**Re: Alectra Utilities Corporation (Alectra Utilities)
2027-2031 Custom Rate Application for Electricity Rates and Charges
Ontario Energy Board (OEB) File Number: EB-2025-0252**

OEB Staff Interrogatories

2027-2031 Custom Rate Application for Electricity Rates and Charges Application Alectra Utilities Corporation (Alectra Utilities) EB-2025-0252 January 22, 2026

Regarding the Future Electric Vehicles Impact section, Alectra Utilities provides *Figure 16. EV Charging Load Peak Demand – Alectra Utilities’ Service Area, 2024-2034.*

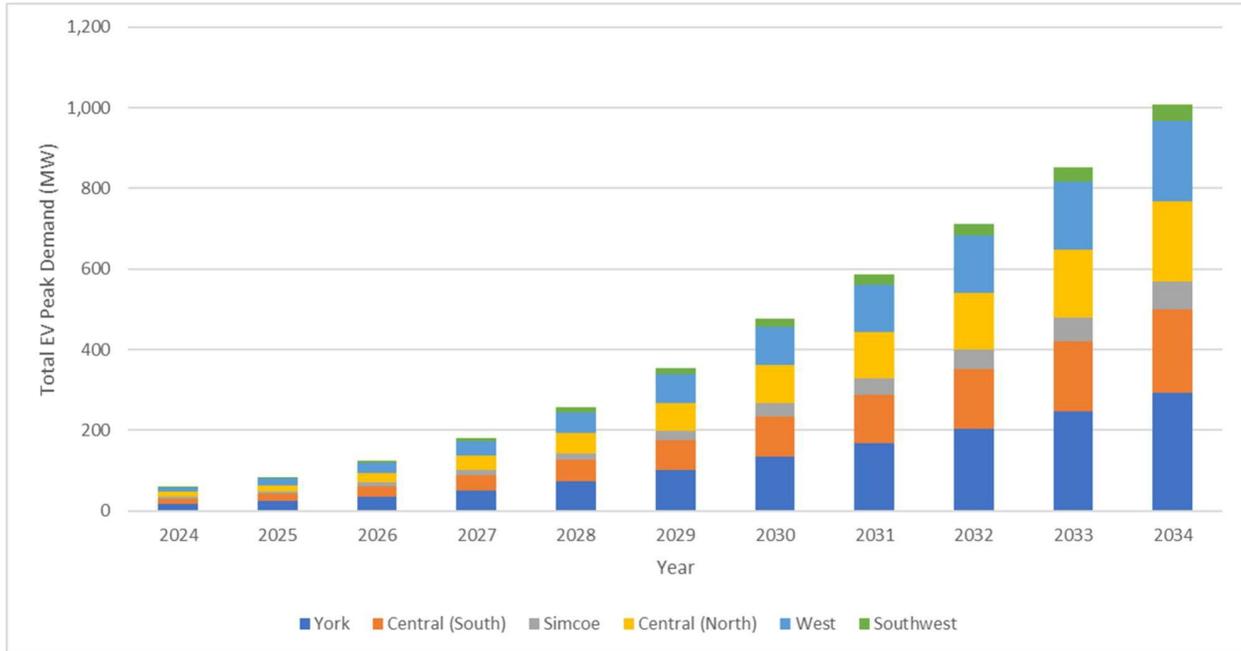
- a) Does Figure 16 show the coincident peak demand (i.e., the coincident demand of all EV charging at the time of summer peak)? If no, please provide a revised Figure 16 showing coincident peak demand
